CITY PLANNING COMMISSION

APPLIC. NO. P-8507

ACTION OF THE ZONING ADMINISTRATOR

On Tuesday, April 18, 1995, the Zoning Administrator approved with conditions a special permit to operate a sidewalk cafe in the public right-of-way for the project known as Z94-110. Findings of Fact and conditions of approval for the project are listed on pages 2-4.

1 FLOOR PLAN

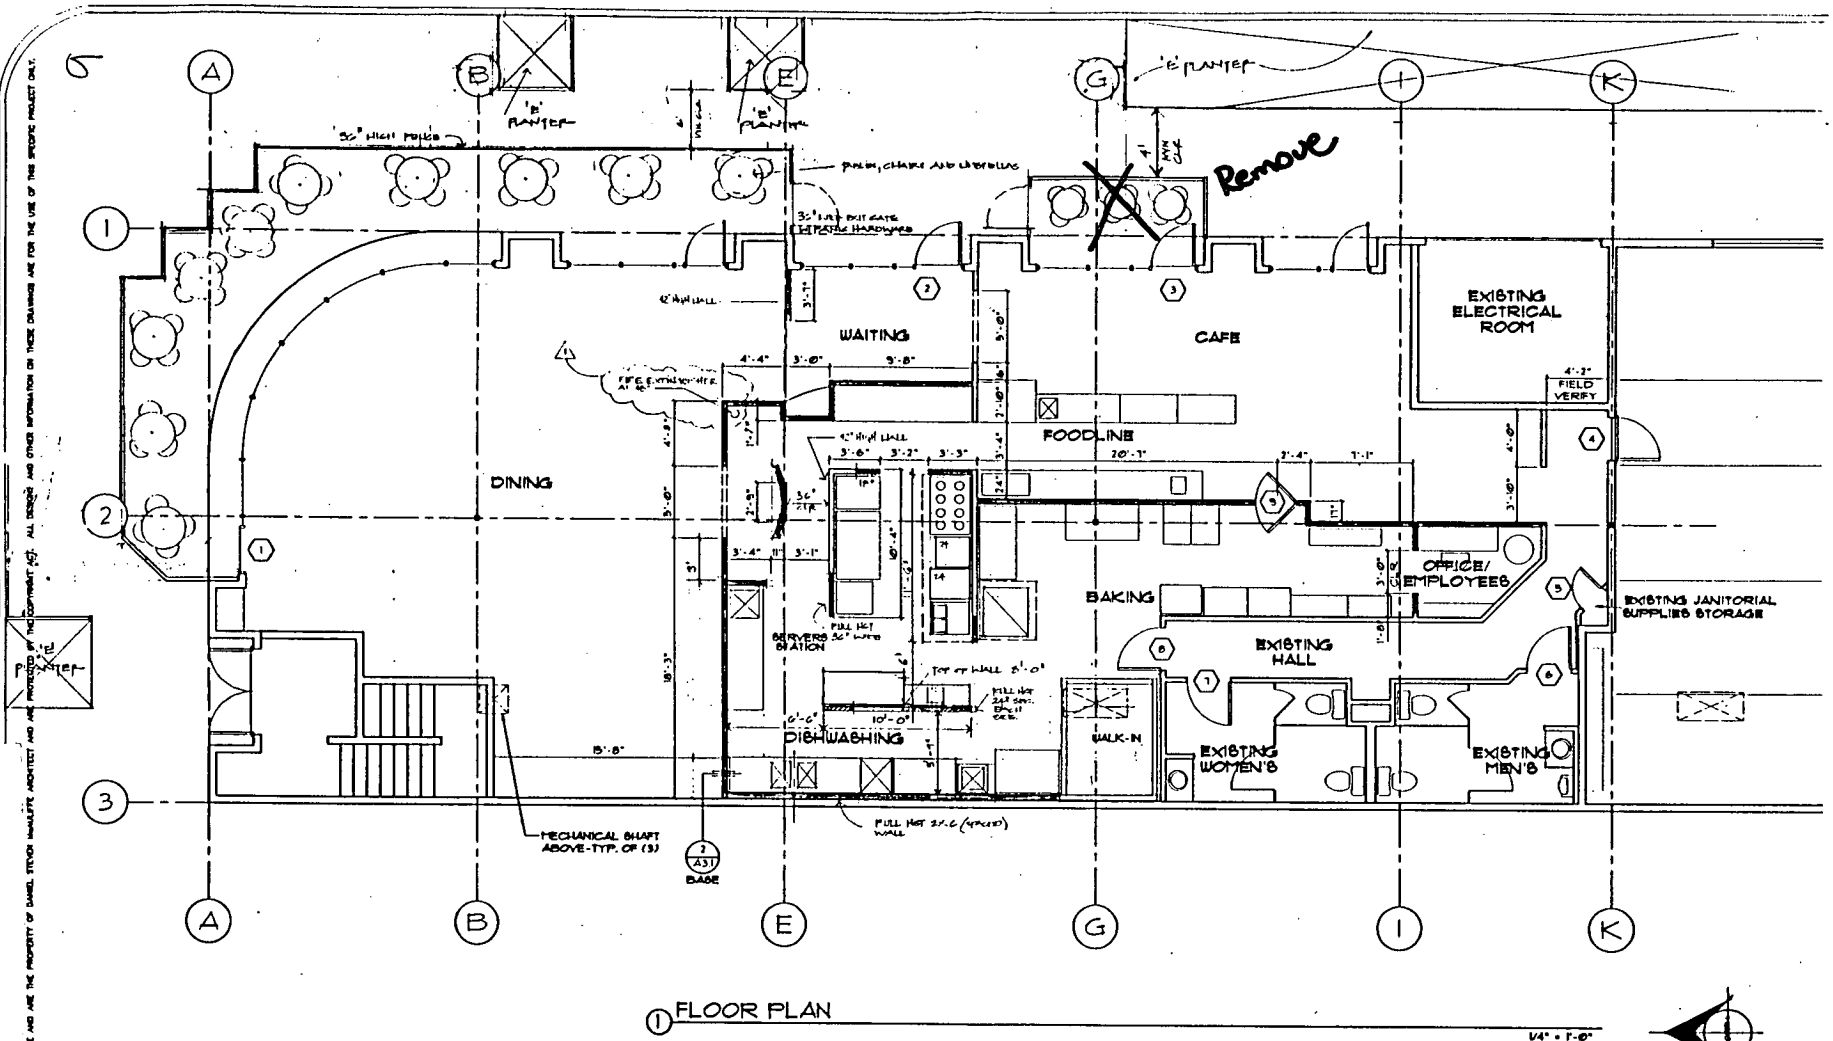
1. The smaller 4 foot by 12 foot enclosed area along 18th Street shall be eliminated.
2. The proposed gates shall be equipped with panic hardware. An area 36 inches minimum in length and the width of the gate shall be delineated with either color strips or color paving to indicate an area not to be obstructed.
3. The applicant shall submit an exhibit of the proposed fence design for Design Review staff review and approval prior to the issuance of an encroachment permit. The fence height shall be no lower than three feet and no higher than four feet. The applicant shall also provide planter boxes adjacent to the fence at the 90 degree bends at the street intersection. An exhibit of the proposed planters shall be submitted for Design Review staff review and approval prior to the issuance of an encroachment permit.

4. No lights or signs shall be attached to or hung from the trees located in the sidewalk area.
5. A clear path way a minimum of 48 inches must be maintained at all times between the fence and all other structures or obstacles in the public right-of-way such as the edge of tree wells, parking meters, signs, etc. The area outside of the enclosed (fenced) area shall be kept free and clear of tables and chairs.

6. The fence location shall conform to the submitted plans.
7. No live music, amplified music or sound system shall be installed or be audible in the sidewalk area.
